SERVICE INFORMATION BULLETIN

APPLICABILITY: 2015-19MY Legacy and Outback
2012-16MY Impreza
2013-16MY Crosstrek
2014-16MY Forester
2015-16MY WRX

NUMBER: 12-308-21
DATE: 01/26/21

SUBJECT: Front Seat Hinge Bolt- Supply Change

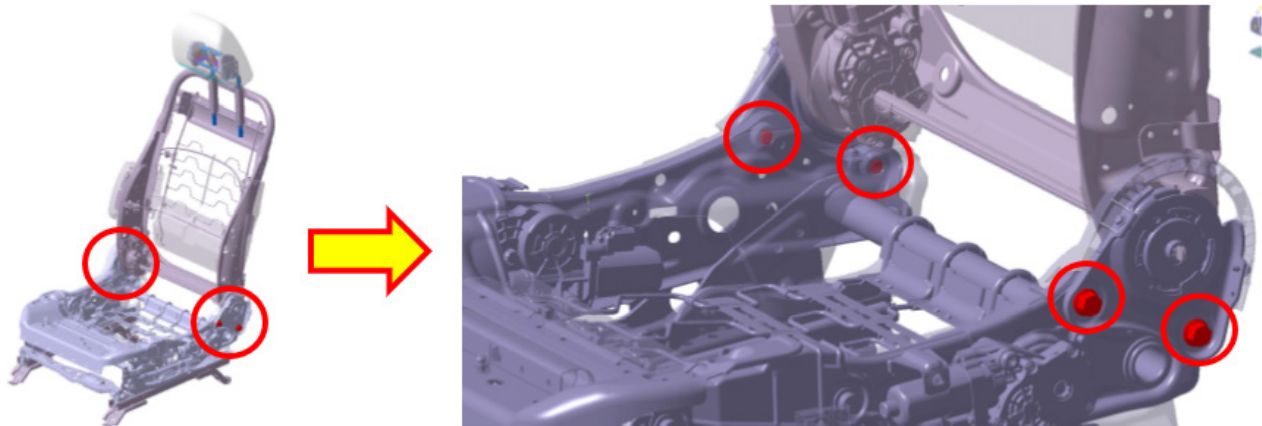
This Service Information Bulletin announces a design change made to the front seat hinge bolts as pictured below.

- The part number for the new bolt is **901000452**.
- The old bolt has been discontinued and replaced by the new.
- The color of the new bolt is changed from a black finish to white.
- The specified torque value remains unchanged.
- The old and new bolts are mutually interchangeable.
